PRODUCT CHANGE NOTIFICATION

Product Category POWER CONNECTORS **20230110-1**

Product Group POWER CONNECTORS GROUNDING AND STEEL

Photos/Drawing (where applicable)

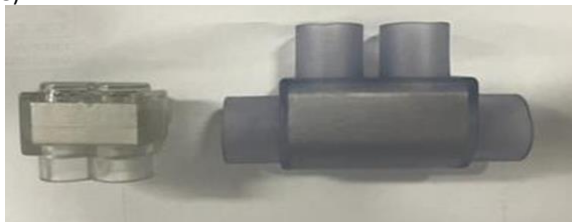
Panduit's Power Connector Multi-Tap product line is changing the outside PVC material. The transitioning is from a clear material to gray/blue translucent material.

Clear Material

Gray/Blue Translucent Material
